SUBJECT: PLANS AND PROPOSAL ADDENDUMS
PROJECT: STP 2023 (675)MM CONTROL: 1433-02-044
COUNTY: COMAL
LETTING: 05/04/2023
REFERENCE NO: 0419

PROPOSAL ADDENDUMS

DESCRIPTION OF ABOVE CHANGES
(INCLUDING PLANS SHEET CHANGES)

BRIDGE CLASS STRUCTURE CROSSING A-1
 @ STA. 130+06.19
 EXIST: 2-10' X 6' X 67.39' MBC (120° LT FWD SKEW)
 WITH FW-S UPSTRM AND DWNSTRM
 TO BE EXTENDED TO
 2-10' X 6' X 89.91' MBC WITH PW-1 DWNSTRM

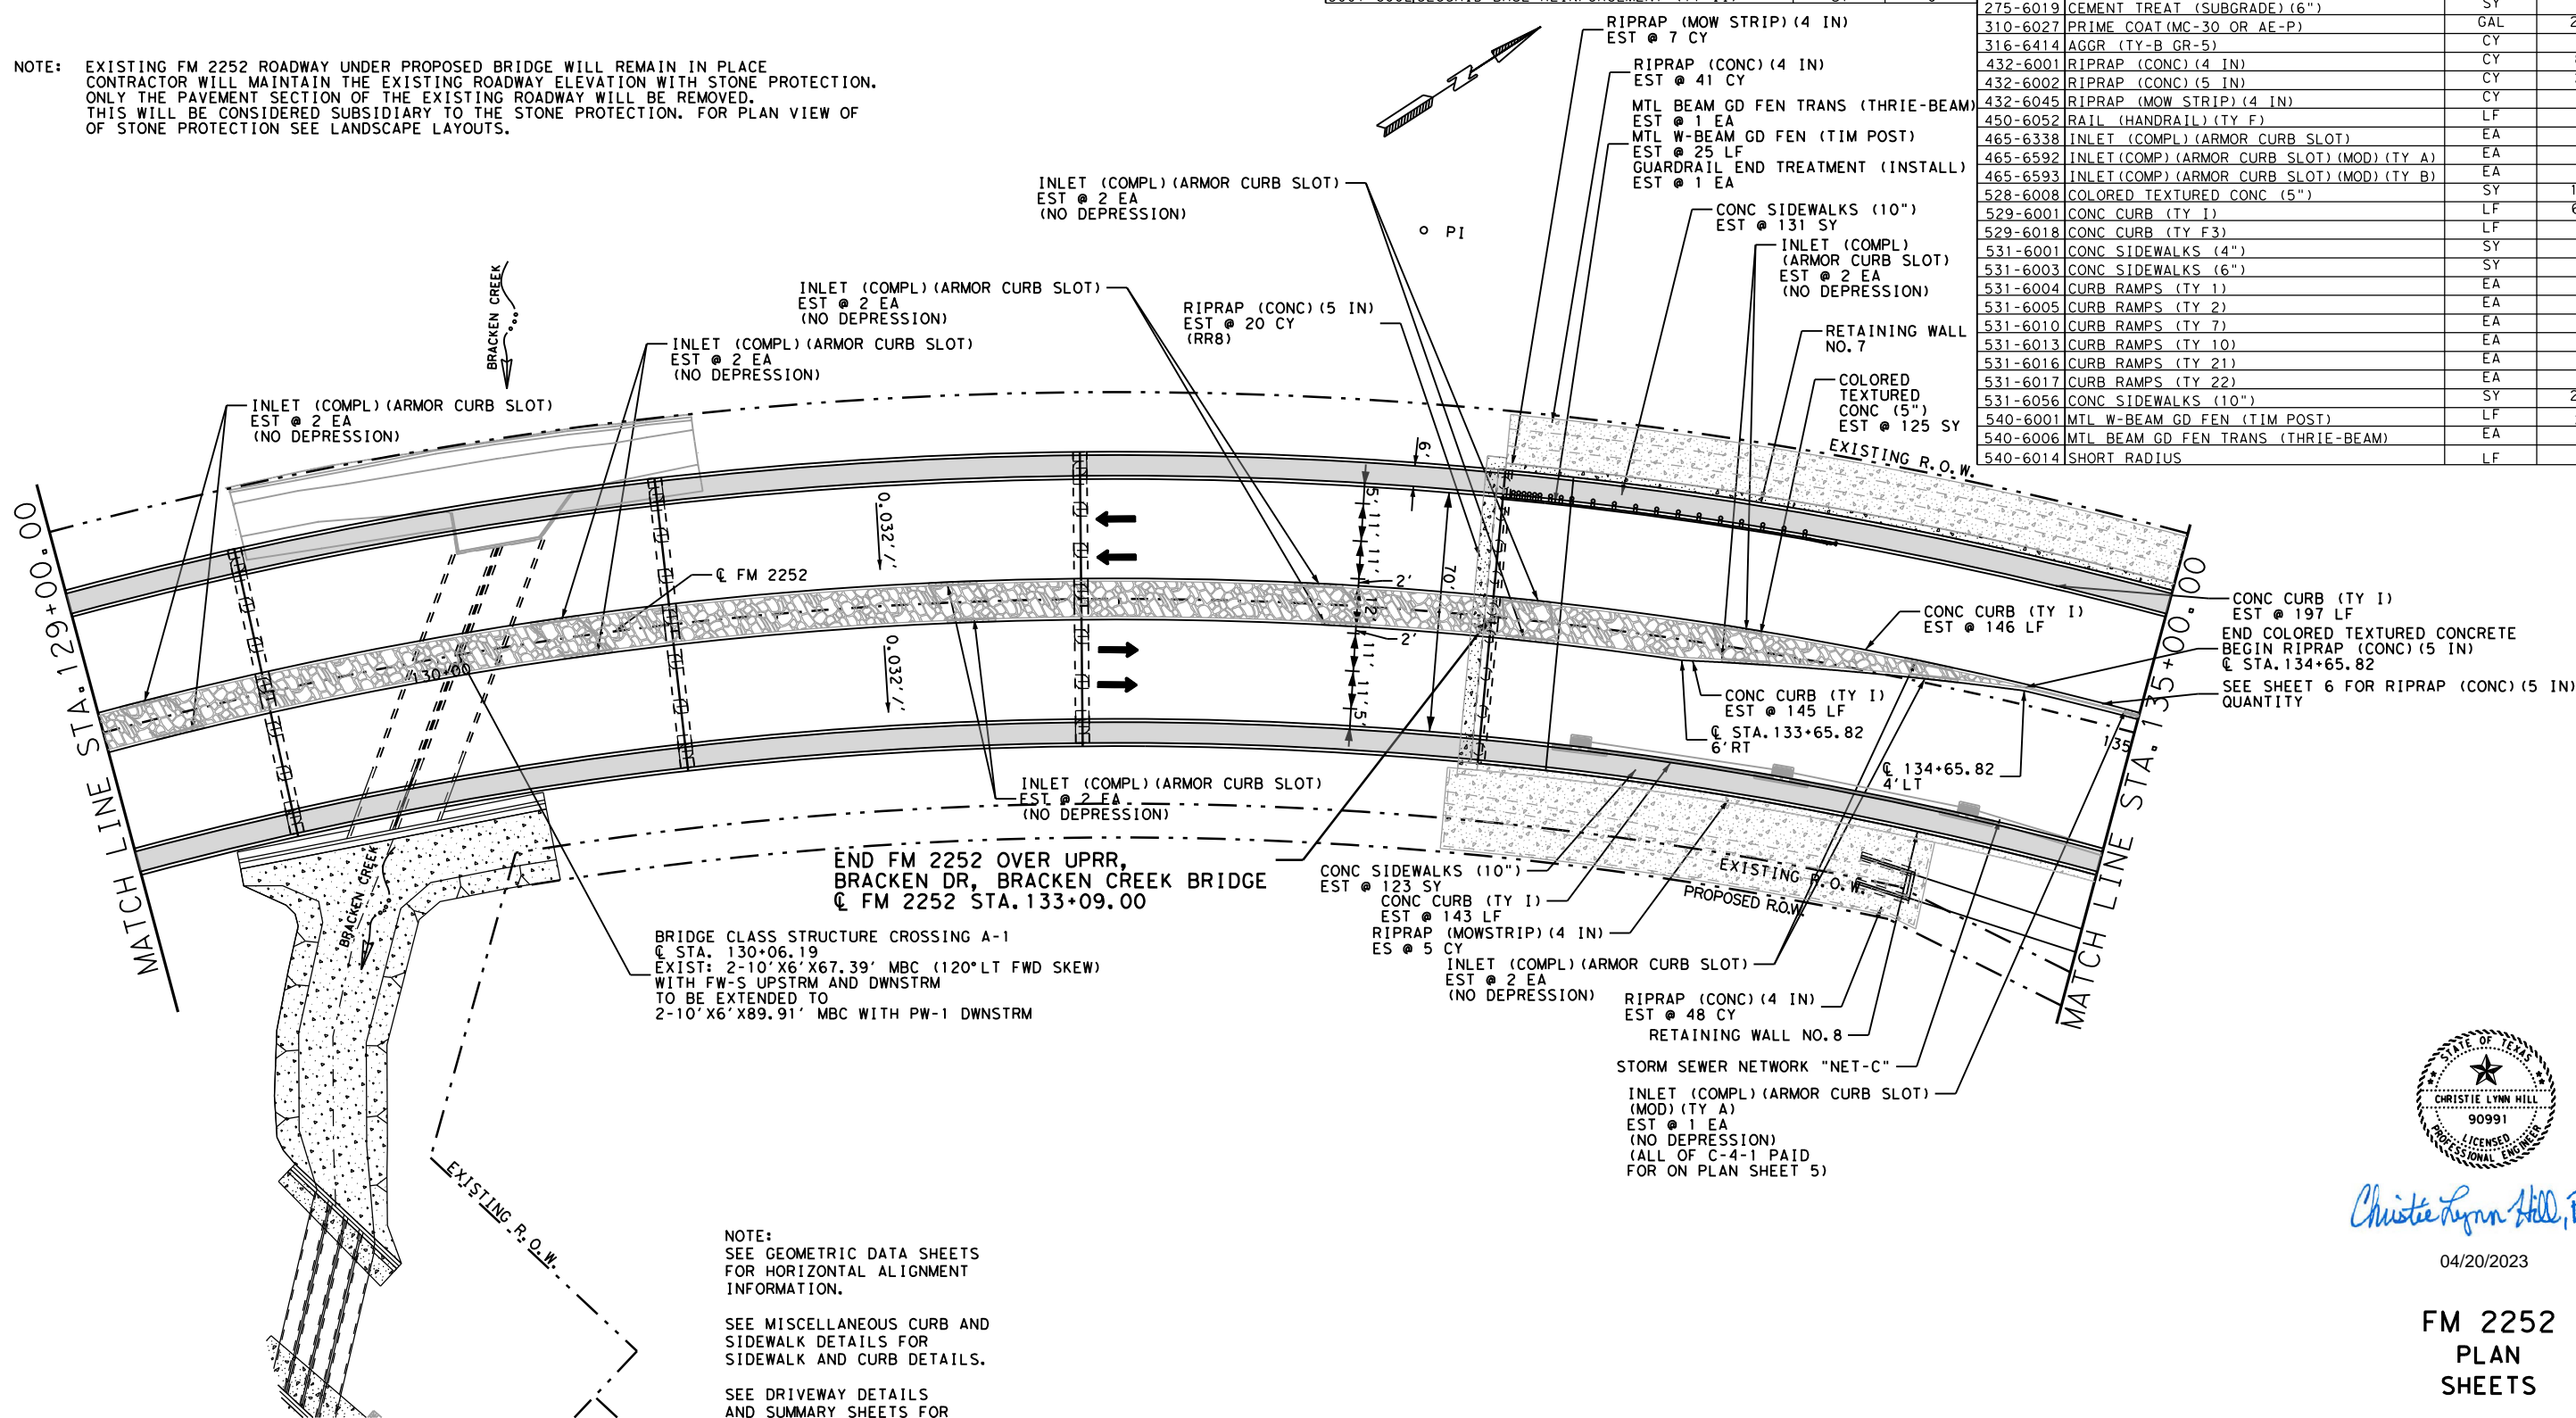
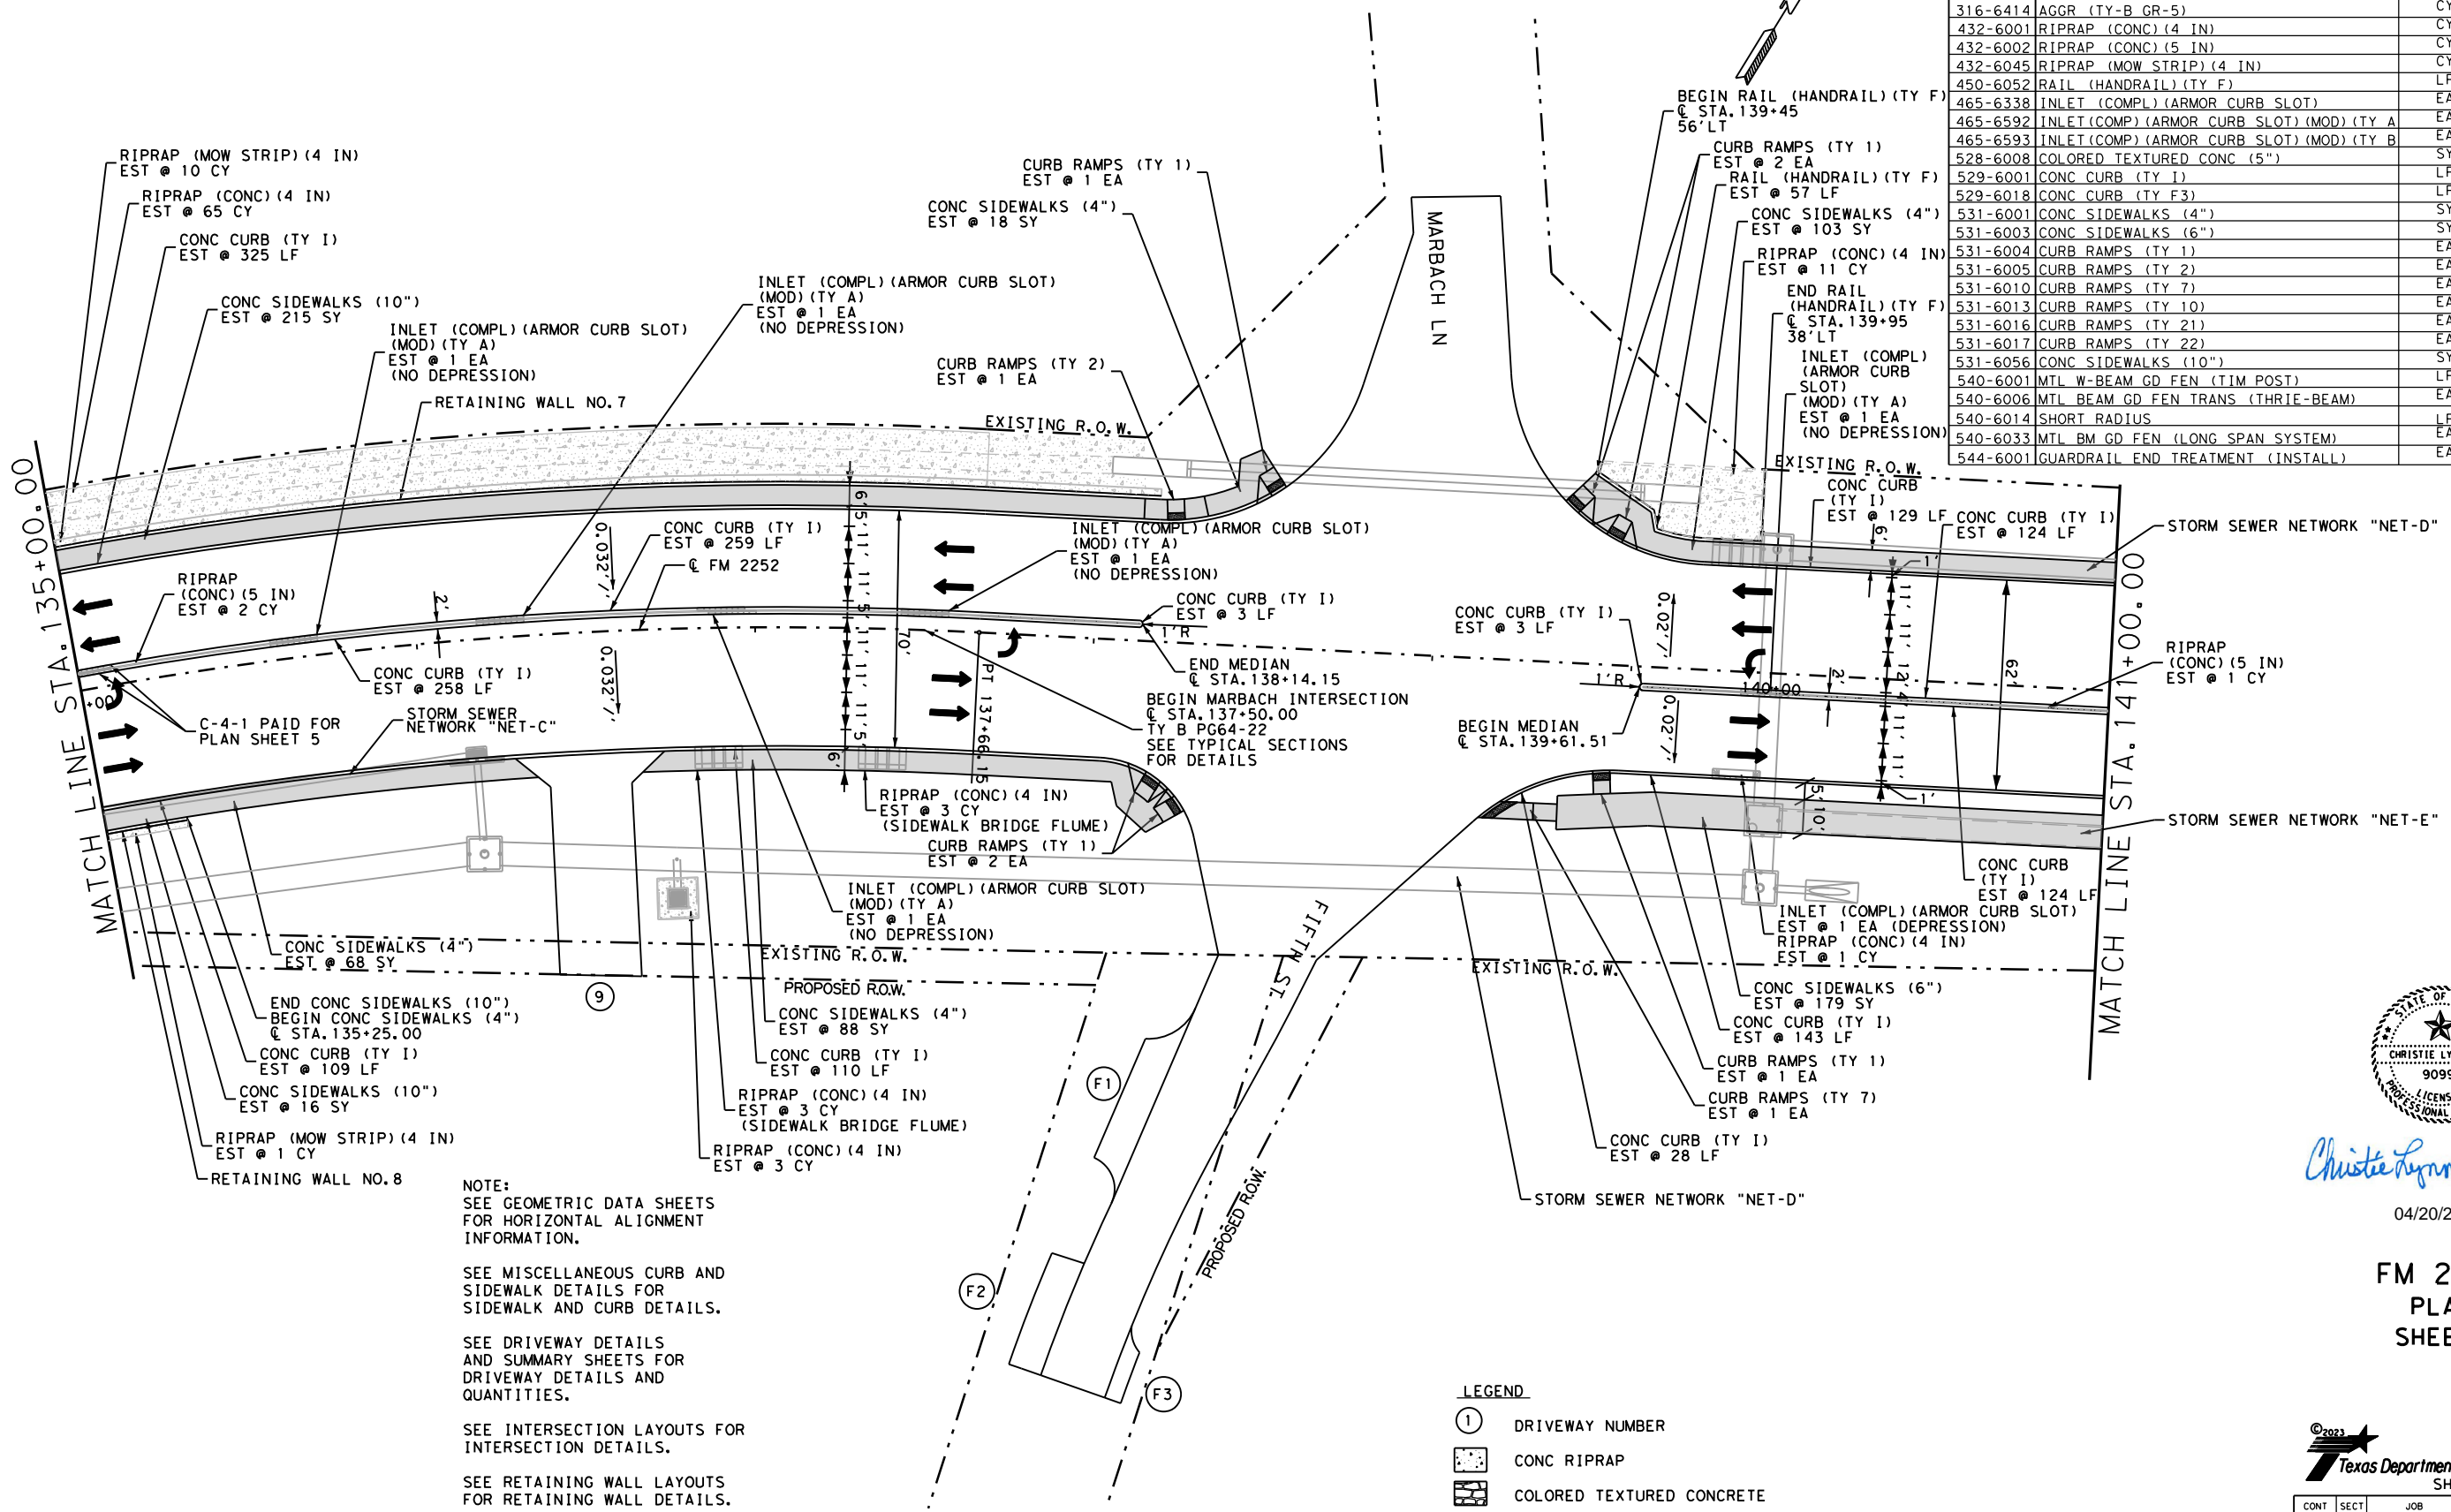
SHEETS 413-449: REPLACED ITEM NO. 545-6017 WITH ITEM NO. 545-6007
